Re: Submission to Modification Proposal - Epiq Lennox Head MP 07_0026 MOD 7

I refer to your email of 8 July 2022 regarding an amended application to modify the current approval relating to Super Lot 5 in the Epiq Estate at Lennox Head.

The following comments are provided by Council staff from a technical perspective for consideration by the Department in the assessment and determination of the modification application.

Plate 3: Landscape plan depicting tree planting adjacent to Blocks 5-9 and 18

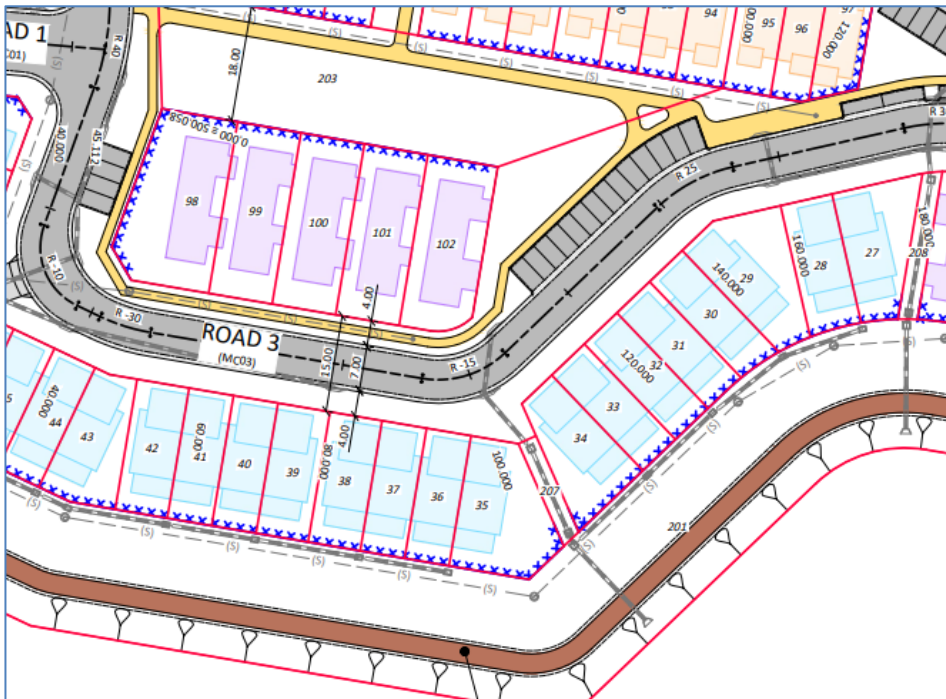
Council's letter of 5 August 2020 raised concerns about the impact of proposed street trees on a range of matters. A review of the applicant's response confirms those matters remain outstanding (refer to Plates 3-5). This issue has been further complicated as the development now includes planting works located immediately adjacent to proposed retaining walls. It is also likely that due to the lack of space the trees, with their lateral spread, will come into direct conflict with the future buildings.

While the applicant states the planting species could be altered to negate the above conflicts, the applicant should be required to address this matter as part of the application (including submission of a revised landscape plan with new species schedule, distances to services and infrastructure identified), as reducing the size and density of the plantings is not likely to have the same effect on screening and reducing the bulk and scale of the future buildings.

Plate 12 - Graph sourced from the 2021 Soil Moisture Report

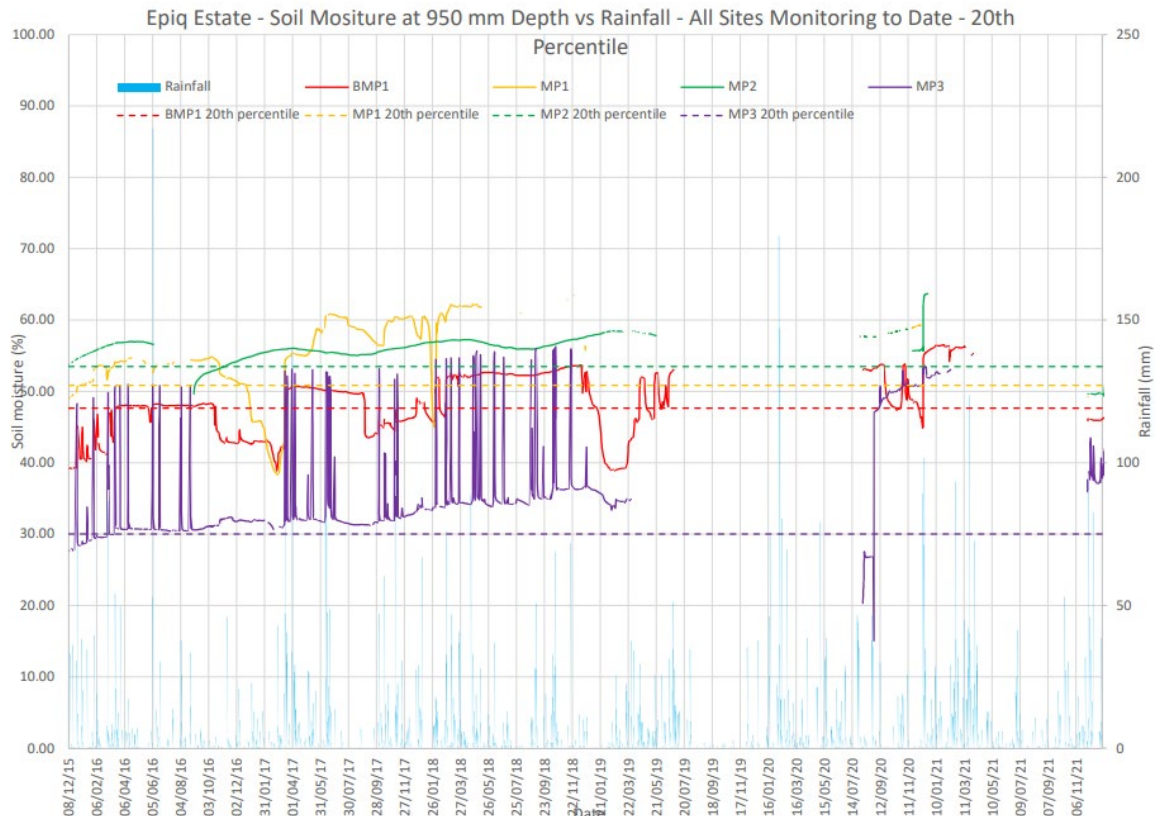
However, as can be seen by Plate 12 the monitoring equipment has largely been dis-functional from April 2019 until December 2021, a period of some 2 1/2 years with one of the loggers MP1 not providing any information since March 2018. The timing of these malfunctions is considered significant in an ecological context, as Ballina LGA experienced a significant drought in 2019, followed by two years above average rainfall associated with La Nina weather patterns.

As the soil moisture monitoring commenced after construction works started at the site it appears the project has no pre development information to compare against the post development moisture results. It is assumed BMP1 was established as reference logger, but as the bulk earthworks for Release Area 5 started in early 2019 the reliance of that logger to operate as reference logger is compromised.

Plate 13: Exert from the submitted plan set showing stormwater discharge into to a non-existent drain.

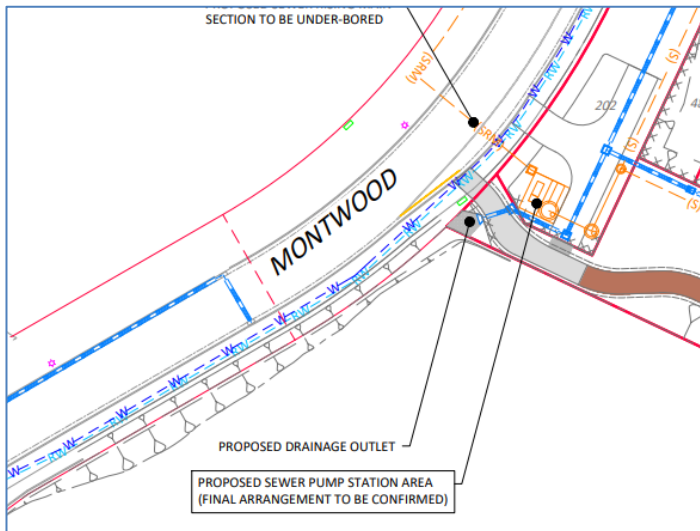
The applicant's letter dated 15 June 2022 states that only minor works are required adjacent to Montwood Drive to correct an existing drainage issue and that Council has endorsed the work. Whilst this is reflective of an in-principal agreement reached between the applicant and Council, the current modification proposes to use the drain to discharge stormwater into the conservation zone (Plate 13).

This requires further assessment as the ecological impact of these works have not been examined in depth. It is noted in this regard that the works will result in the loss of an area of mapped Freshwater Wetland EEC depicted in Plate 14. Also, the hydrological capacity of the drain to convey the stormwater has not been assessed.
